Correspondence

Comments on “Novel Combinatorial Constructions of Optical Orthogonal Codes for Incoherent Optical CDMA Systems”

Fig. 1. Balanced MUI cancellation decoder scheme proposed in [1].

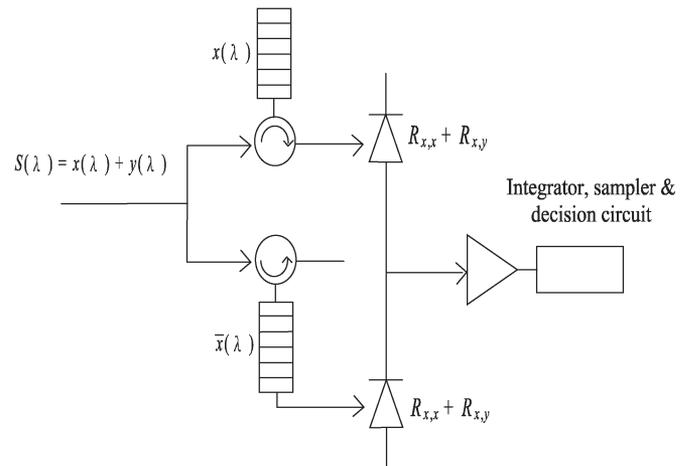
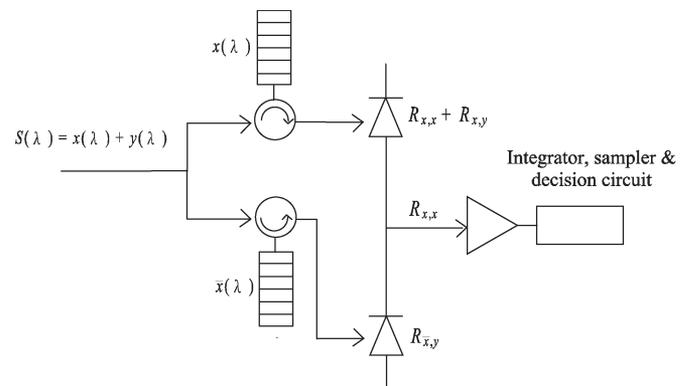
In the above paper [1], the balanced multiuser interference (MUI) cancellation decoder shown in [1, Fig. 1(b)] is erroneous and cannot function. The authors state that this balanced decoding scheme allows the MUI cancellation in the case when unipolar sequences having in-phase cross correlation 0 or 1 are employed. The mutual in-phase cross correlation of two code sequences $x = (x_1, x_2, \dots, x_v)$ and $y = (y_1, y_2, \dots, y_v)$ is defined as

It is assumed that the signal at the upper photodiode is proportional to $R_{x,x} + R_{x,y}$ and the signal at the lower photodiode is proportional to $R_{x,y}$, where x is the desired sequence and y is the interfering sequence. Hence, the MUI can be completely removed with balanced detection [1].

However, the above statement is not true. In the upper branch of the balanced MUI cancellation decoder, since the fiber Bragg grating (FBG) array employed in this branch has the spectral distribution $x(\lambda)$ corresponding to the code sequence x , the signal at the upper photodiode is indeed proportional to $R_{x,x} + R_{x,y}$. But in the lower branch, since the FBG array has the complementary spectral distribution $\bar{x}(\lambda)$, the signal at the lower photodiode should also be proportional to $R_{x,x} + R_{x,y}$ as shown in Fig. 1 (because the spectral components corresponding to $x(\lambda)$ will pass through this FBG array completely). Therein, $S(\lambda)$ is the spectral distribution of the received optical signal and $y(\lambda)$ is the spectral distribution corresponding to the code sequence y . Hence, if this balanced decoding scheme is employed, there will be no signal appearing at the output.

In summary, the balanced MUI cancellation decoder shown in [1, Fig. 1(b)] is erroneous and therefore cannot be used to decode the proposed code families based on MOLRs, integer lattice design, and AG. In order to make these code families applicable to spectral-amplitude-coding systems, the authors may need to propose another decoding scheme to solve this problem.

This problem might be caused by a mistake made by the authors during the preparation of the drawings. The balanced MUI cancellation decoder should be revised as shown in Fig. 2. Unfortunately, this decoder can work only when $R_{x,y} = R_{\bar{x},y}$. It means that the in-phase cross correlation of any two code sequences must be fixed and equal to half of the code weight. Since the in-phase cross correlation for any of the optical orthogonal code (OOC) families based on mutually orthogonal Latin rectangles (MOLRs), integer lattice design, and affine geometries (AGs) proposed by the authors is not fixed and is not equal to half of the code weight—the decoder shown in Fig. 2 cannot be used to decode these code families.

Fig. 2. Revised structure of the balanced MUI cancellation decoder.
